**RE: MINOR CHANGE IN ACCORDANCE WITH S81 OF THE PLANNING ACT 2016 – MATERIAL CHANGE OF USE (DEVELOPMENT PERMIT) FOR RESIDENTIAL CARE FACILITY UPON LAND AT 80 ARALUEN STREET, KEDRON QLD 4031 (LOT 10 ON SP316109)**

## MINOR CHANGE APPLICATION

Figure 4: Proposed Location of Transformer

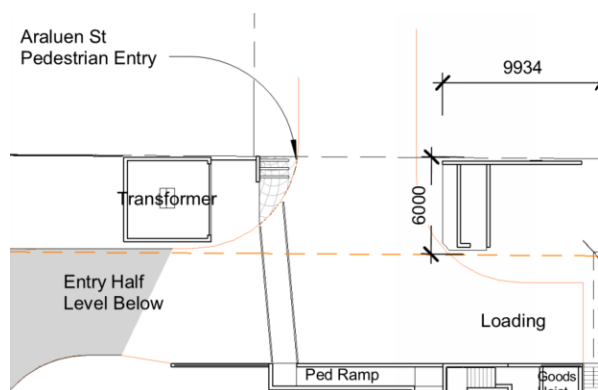
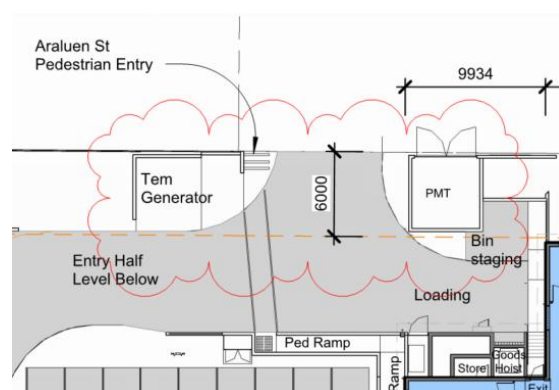
The pad mounted transformer (PMT) was originally approved on the western side of the Araluen Street driveway. It is proposed to relocate the PMT to the eastern side of the site access due to constraints with providing the electricity connection to the PMT from the road reserve, with an improved outcome able to be achieved with the revised design, which retains the existing street trees on Araluen Street. The relocation facilitates improved coordination and connection of underground services associated with the development, whilst maintaining the transformer's functional role in servicing the development.

The new location of the transformer will continue to front Araluen Street. The PMT is located within an area of the site providing limited landscaping opportunities, with the approval incorporating predominantly groundcover planting directly adjoining the driveway and in ground planting offering tree planting along the balance of the frontage to Araluen Street. As a result, the relocation of the PMT does not significantly impact on the landscape design and amenity of the site noting this area provided predominantly groundcovers, and does not restrict the ability to continue to provide landscape trees along the balance of the Araluen Street frontage consistent with the approval.

As illustrated in Figure 3 and Figure 4, the change results in the same operational outcome with the proposed amendment limited to the repositioning of the transformer within the frontage area.

Figure 6: Proposed Southern Elevation Plan

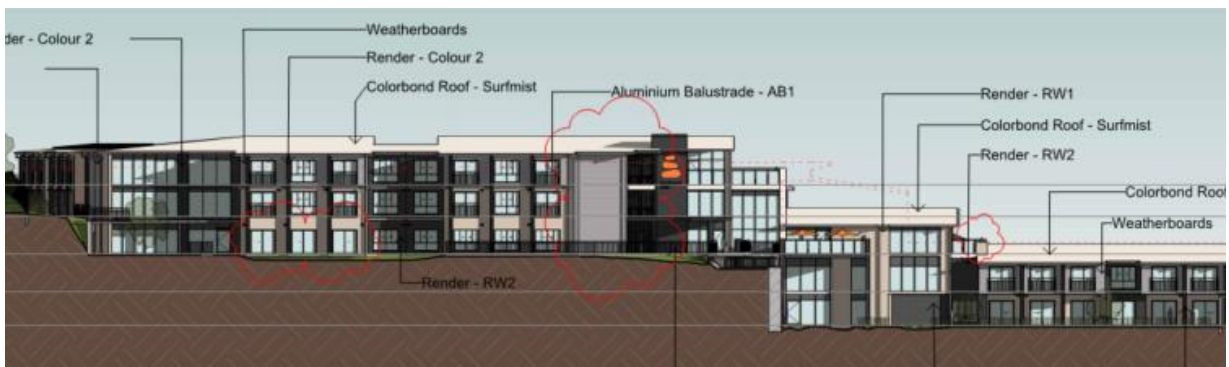
The proposed amended elevations are shown in Figure 6 and Figure 8 compared with the approved facades in Figure 5 and Figure 7 respectively. This comparison demonstrates the limited nature of the changes, converting seven (7) selected windows along the southern and western elevations to sliding glass doors, minor slab extensions and associated façade treatments. Additionally, changes to the glazed balustrade on the Level 3 communal area balcony have been updated to rendered blockwork parapet to ensure water tightness to this area (as shown in Figure 6). The overall building form and presentation remain substantially consistent with the approved development.

In addition, the detailed design process has confirmed the material palette for this section of the southern elevation, with weatherboards proposed along the frontage. These amendments are minor in nature and do not materially alter the appearance, scale or overall architectural presentation of the approved development.

Figure 10: Proposed Roof Form Level 5

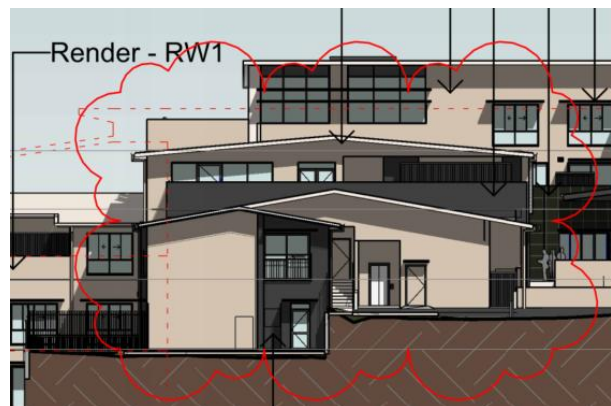
The roof above the Level 4 staff room and wellness area is proposed to change from a hip roof to a gable roof (refer to Figure 9 and Figure 12). Additionally, the roof above Level 5 is proposed to have a 200mm increase in height to improve constructability and accommodate detailed building design requirements (refer to Figure 10).

The proposed roof form changes are as a result of input from the builder and structural design team to improve buildability for the development, resulting in minor roof changes. The amendments to the roof and do not alter the approved building footprint, overall building height, or the architectural character of the development. As a result, the overall appearance of the development with the proposed changes remains substantially consistent with the approved plans.

Figure 14: Proposed Boundary Section 9 - Showing Retaining Wall

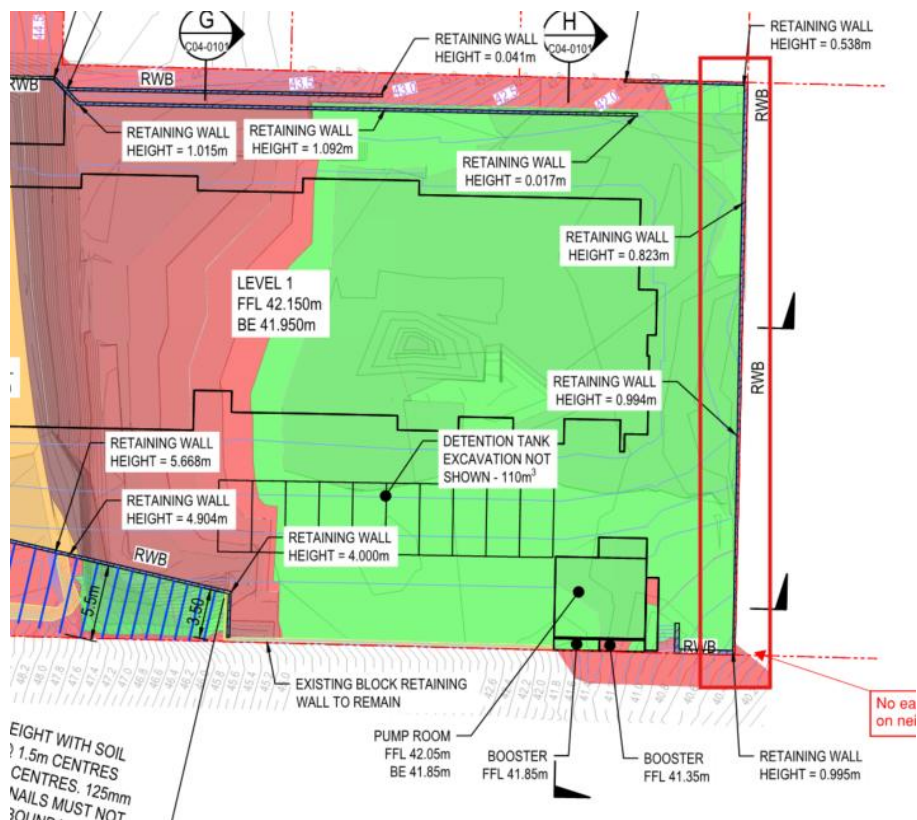
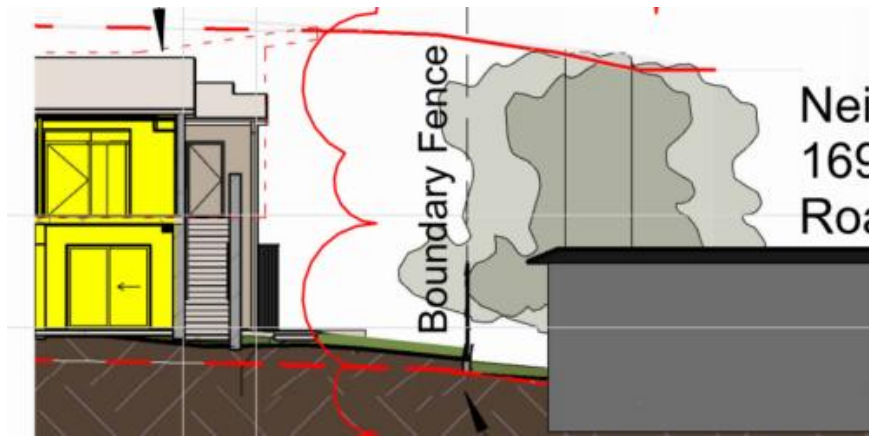
The site exhibits significant topographical variance, with levels ranging from approximately 56m AHD along the western boundary to 41m AHD along the eastern boundary. Since the development approval was granted, the project has progressed through detailed design and construction documentation. As outlined in Section 2 of this report, a Development Permit for Operational Works (Council Ref: A006856592) was issued on 22 October 2025, which included detailed civil engineering plans for retaining wall structures along the eastern boundary. The approved retaining wall varies in height from approximately 0.538m to 0.995m. An extract of the approved Operational Works drawings is provided in Figure 13.

The proposed amendment seeks to update the approved architectural plans to ensure consistency with the subsequently approved Operational Works drawings (refer to Figure 14). The amendment does not alter the approved development outcome and merely reflects the retaining wall arrangement already endorsed through the Operational Works approval process.

Figure 16: Proposed Pump Room Layout

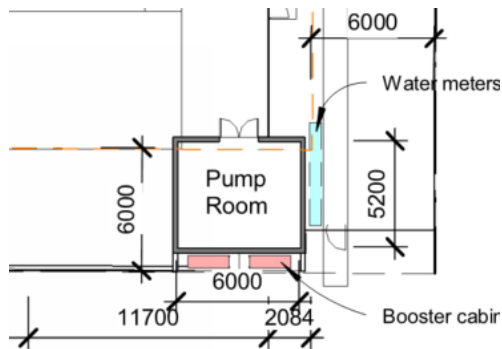
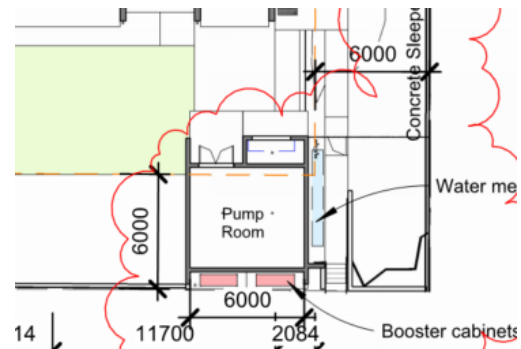
Additionally, as part of the above Operational Works approval, the pump room floor levels and layout have been adjusted slightly to take into consideration the proposed earthworks in this portion of the site (Refer to Figure 16). Further detailing regarding the pump room and related services are subsequently also shown within the revised plan. Notwithstanding, the location of the pump room, with regard to setback to the side boundary and scale of the infrastructure remains in accordance with the approval.
